भारत सरकार-रेल मंत्रालय  
अनुसंधान अभिकल्प और मानक संगठन  
लखनऊ-226011  
Government of India - Ministry of Railways  
**Research, Designs & Standards  
Organization, LUCKNOW - 226011**

**MODIFICATION SHEET No.RDSO/2015/EL/MS/0446 Rev.'0' dated 07.12.2015.**

Modification in loco roof bars and fittings on conventional locomotives similar to of three phase locomotives.

S.No.	PART NO.	DESCRIPTION	QUANTITY	MATERIAL SPECIFICATION
REF :  SCALE: NTS APPD. BY  24/6/15				
MODIFIED ROOF BAR ARRANGEMENT OF WAG-7 CLASS LOCOMOTIVES			FIRST ISSUED	
RD SO ELECT. DTE			SUPERSEDES	
SKEL 5005, Alt.'O'			SUPERSEDED BY

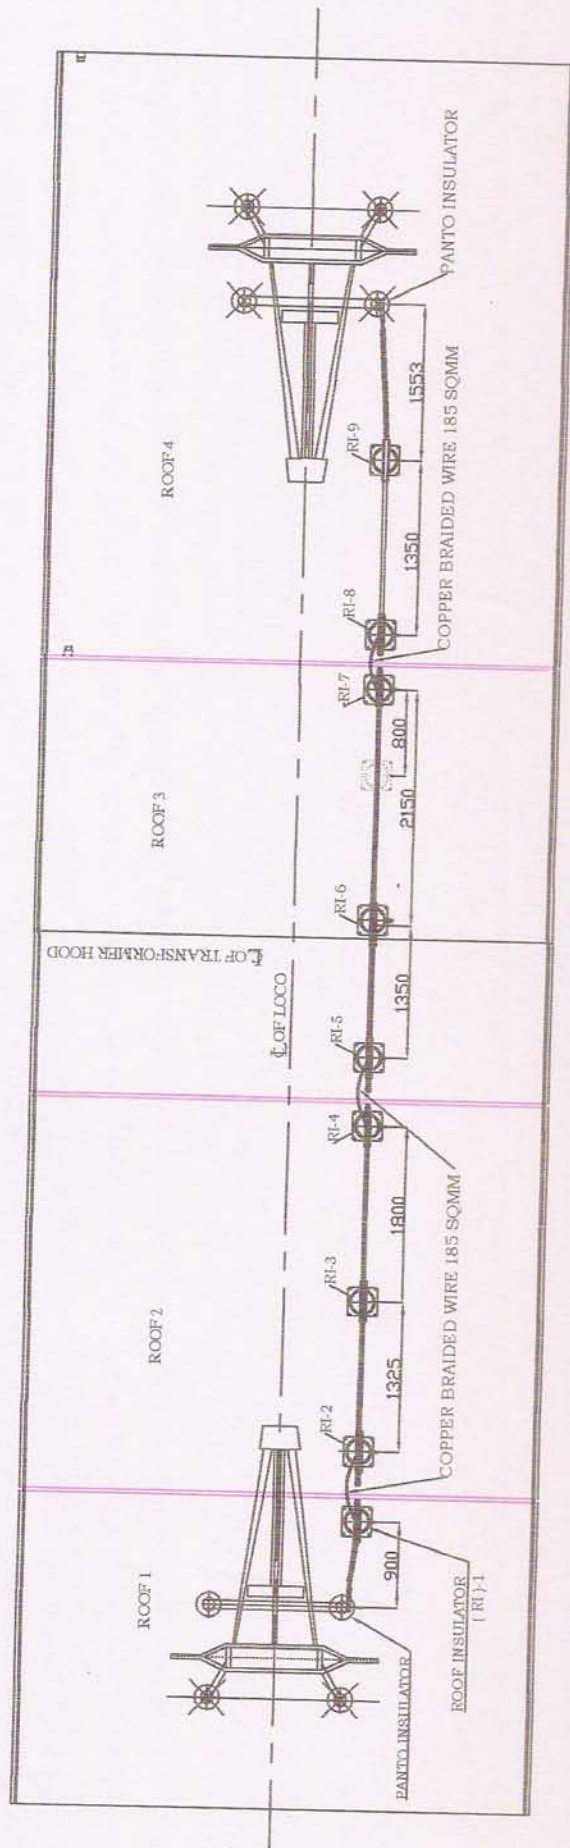
- i) Additional insulator no.1 on roof-1 is required to be fixed as per attached drawing no. SKEL-5005, Alt. 'O' on modified insulator base.
- ii) Additional insulator no. 4 on roof-2 is required to be fixed as per attached drawing no. SKEL-5005, Alt. 'O' on modified insulator base.

- iii) Existing insulator no. 7 is required to be shifted towards roof no. 4 approximately 800 mm from its existing location as shown in attached drawing.

- iv) Roof bars to be fitted on insulator head between panto insulator (roof-1) and roof insulator no.1, between roof insulator no. 2 & 4, between roof insulator no. 5 & 7 and between roof insulator no. 8 & panto insulator (roof 4) by U clamp tightly as per drawing.

- v) Between the edge of the roof bars i.e. between roof insulator 1 & 2, between roof insulator 4 & 5 and between roof insulator 7 & 8, roof bars to be connected by 185 sq. mm. copper braided wire clamped with S.S. clamp with bracket on both the ends.

S/N	PART NO.	DESCRIPTION	QUANTITY	MATERIAL SPECIFICATION
REF :			SCALE: NTS	APPD. BY <i>anil</i>
MODIFIED ROOF BAR ARRANGEMENT OF WAP-4 CLASS LOCOMOTIVES				FIRST ISSUED
RDSO ELECT. DTE				SUPERSEDES
SKEL 5006, Alt. '0'				SUPERSEDED BY

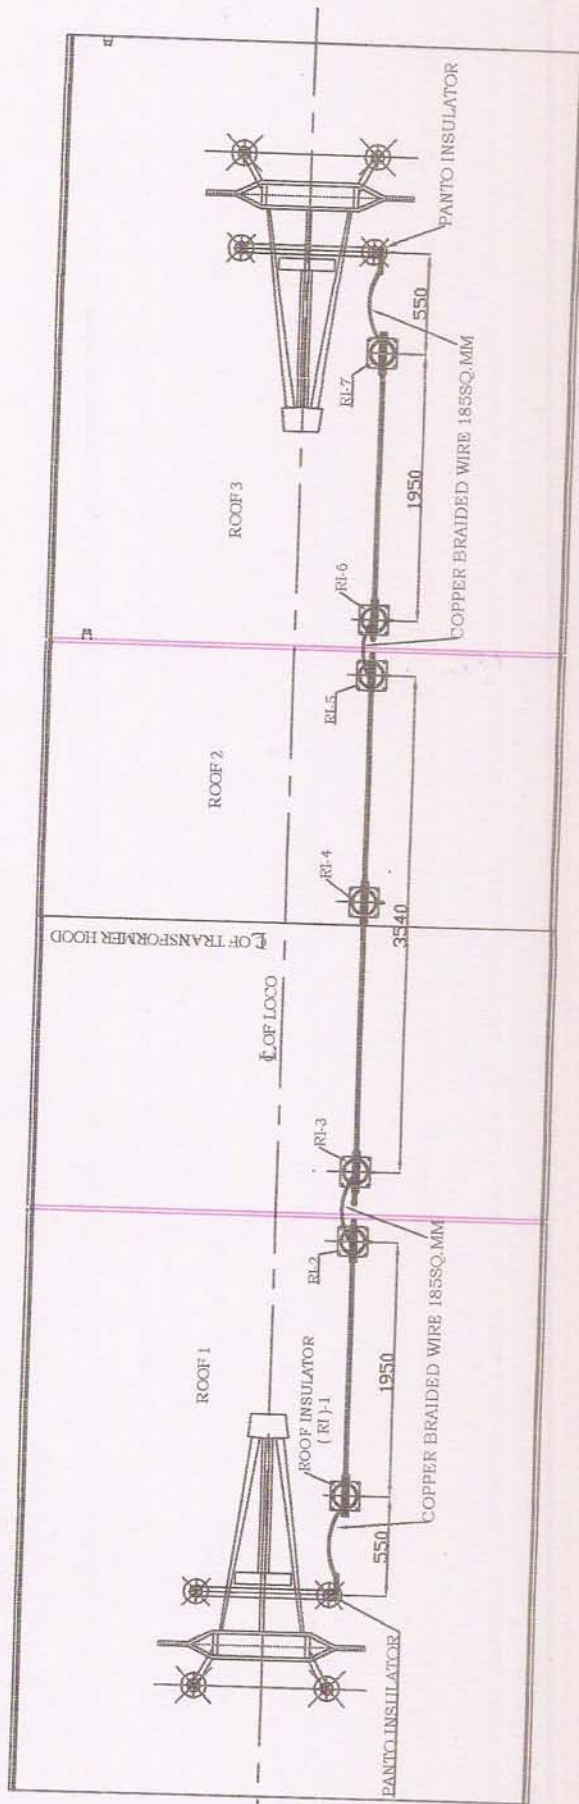
- i) Two nos. of additional insulators one each on roof no. 1 & 3 are required to be fixed as per attached drawing no. SKEL-5006, Alt. 'O'. Insulators to be fixed on roof no. 1 & 3 on modified insulators base. Rest of the insulators to be kept unchanged.

- ii) Roof bars between insulator 1 & 2, between 3 & 5 and between 6 & 7 to be fitted on insulator head by U clamp tightly as per drawing no. SKEL-5006, Alt. 'O'.

- iii) Between the edge of the roof bars i.e. between insulator 2 & 3 and between insulator 5 & 6, roof bars to be connected by 185 sq. mm. copper braided wire clamped with S.S. clamp with bracket on both the ends.

- iv) On roof no. 1, the connection between panto insulator and roof insulator no.1 shall be done using 185 sq. mm. copper braided wire. On panto insulators, 185 sq. mm. copper braided wire shall be clamped with copper bracket and on roof bar insulator no.1 with S.S. bracket and S.S. clamp.

- v) Same process to be applied for connection of roof bar with panto in roof no. 3 also.
